Joint Meeting of the RID Committee of Experts and the Working Party on the Transport of Dangerous Goods

Proposals for amendments to RID/ADR/ADN: new proposals

Proposal to clarify 5.2.2.2.1.2 Provisions for labels of Cylinders for Class 2

Transmitted by the European Industrial Gases Association (EIGA)

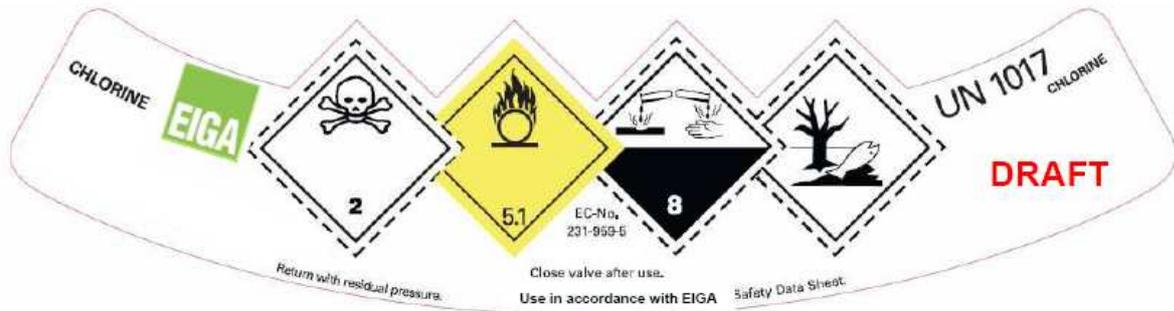
5. In order to clarify this, the proposal is to amend 5.2.2.2.1.2 with the addition of "and marks".

An example of a label for a chlorine cylinder is shown below detailing the labels and the environmentally hazardous substance mark:

"5.2.2.2.1.2 Cylinders for class 2 may, on account of their shape, orientation and securing mechanisms for carriage, bear labels **and the environmentally hazardous substance mark** representative of those specified in this section, which have been reduced in size according to ISO 7225:2005, for display on the non-cylindrical part (shoulder) of such cylinders. Labels **and the environmentally hazardous substance mark** may overlap to the extent provided for by ISO 7225 "Gas cylinders- Precautionary labels", however, in all cases, the labels representing the

primary hazard and the numbers appearing on any label shall remain fully visible and the symbols recognisable.”.
